In-Person Public Information Center • Tuesday, March 28, 2023

COMMENT RESOLUTION SUMMARY

Prepared By: NV5 and Pennington Borough

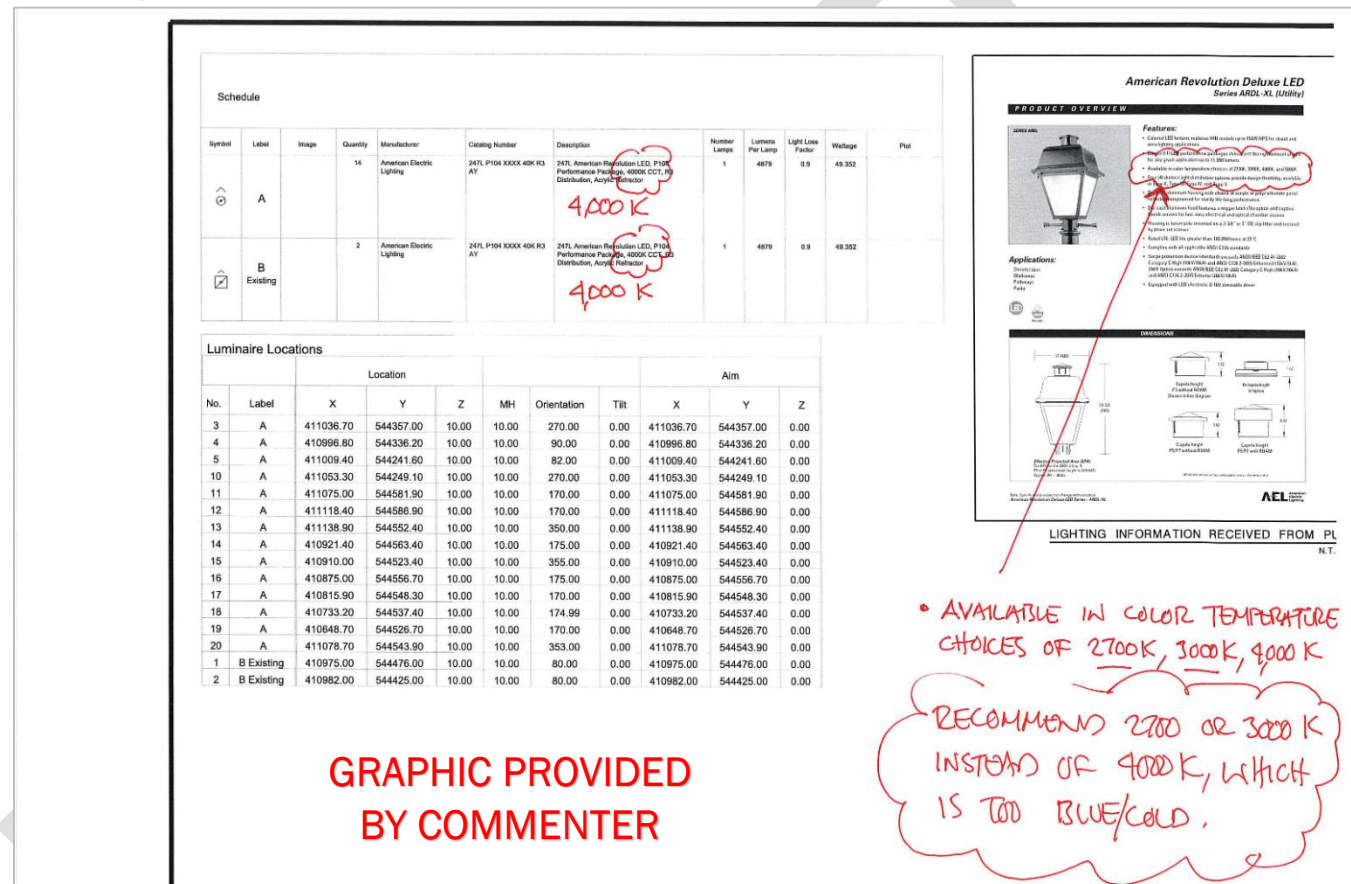
I note on the consultant boards that specified streetlamps include 400K color temperature lamping. I think this is too cold and blue-ish and will detract from street character of historically appropriate street lamps.

Attached Lighting information from the same presentation board indicates that standard 2700K and 3,000K color temperatures are also available. 2700K would be preferred, but either 2,700K or 3,00K would be acceptable.

Following coordination between Pennington Borough and Public Service Electric and Gas (PSE&G), PSE&G is planning to install LED replacement lights for the Phase 1 portion of the project, which will match the proposed pedestrian lights in Phase 2 (this project) - the existing phase 1 lights (100W High Pressure Sodium [HPS]) will be replaced with the 4000K LED lights, since PSE&G will no longer stock and maintain the HPS Post top lights.. It is the understanding of NV5 that PSE&G only stocks 4000K LED lights in the post top Dayform Traditionaire luminaire for cost effectiveness and ease of maintenance. The 4000K LED (4,818 Lumens) is more energy efficient (better light output) than the 2700K LED (4,360 Lumens) and 3000K LED (4,476 Lumens) for the same wattage (46W). While the Dayform Traditionaire luminaire is available from the manufacturer with 2700K and 3000K LEDs, PSE&G will not be able to maintain the luminaires for the reasons stated above.

See Photos Below that were provided by Commentor:

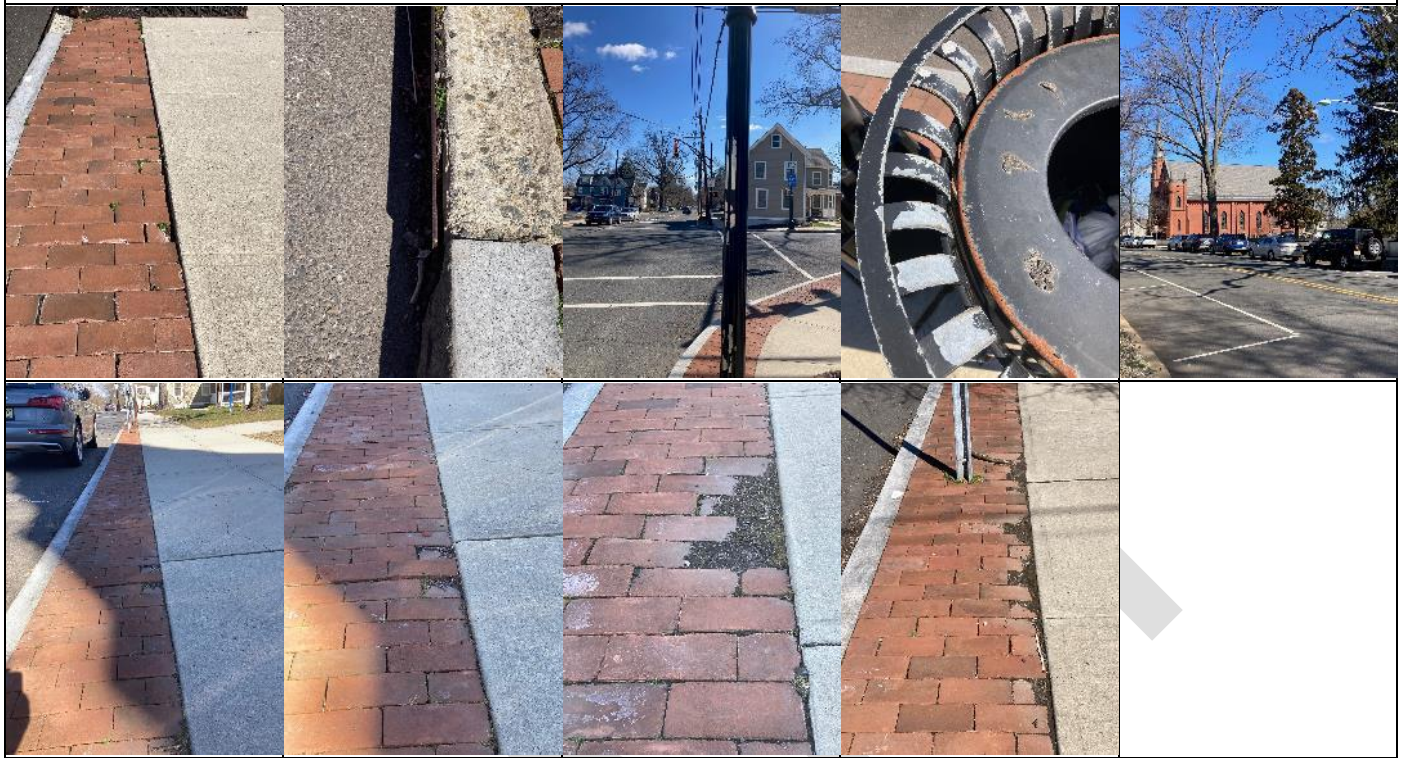
1. Maintenance – The Streetscapes project requires a great deal of maintenance and some replacement or repair. If you see the attached photos, you can see:

- The brick pavers have not aged well. They are chipped and heaving, creating uneven walking surfaces and pooling areas. They don't look great, and they are not that old.
- rusting metal garbage cans in need of replacement
- many lampposts where paint has come off in large sections and need to be repainted.

This is not an argument against the project but just an awareness that work needs to be done to maintain and also restore. Pavers are by nature higher maintenance than grass ways. I know you want to maintain the same look/feel as the first phase of the project but can more long lasting materials be chosen that look the same or similar?

Response | [Maintenance of existing streetscape items for Phase 1 is outside the scope of services for this project. Future maintenance responsibilities for the Phase 2 improvements \(this project\) will be the responsibility of Pennington Borough. The intent of the project is to replace existing segments of concrete sidewalk with concrete while resetting existing paver sidewalk where present within the project limits.](#)
